AIRWORTHINESS GROUP CHAIRMAN'S FACTUAL REPORT

NTSB No. CEN15MA290

Airbus Helicopters Service Bulletin No. AS350-67.00.66 Revision 1 (31 Pages)

Functional check procedure for the tail rotor load compensator

Figure 1 - ARRIEL 2B

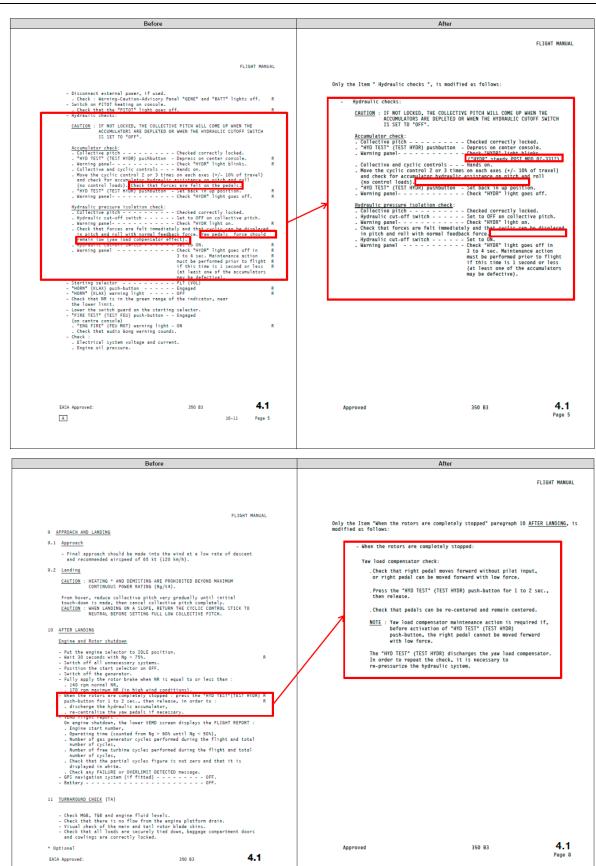
- Figures 1 and 2, for AS350 B3 version helicopters equipped with an ARRIEL 2B engine,
- Figures 3 to 5, for AS350 B3 version helicopters equipped with an ARRIEL 2B1 engine,
- <u>Figures 6 and 7</u> (EASA) or <u>Figures 8 to 10</u> (FAA/ANAC/IAC-AR), for AS350 B3e version helicopters (or H125 Commercial name of AS350 B3 version helicopters equipped with an ARRIEL 2D engine.
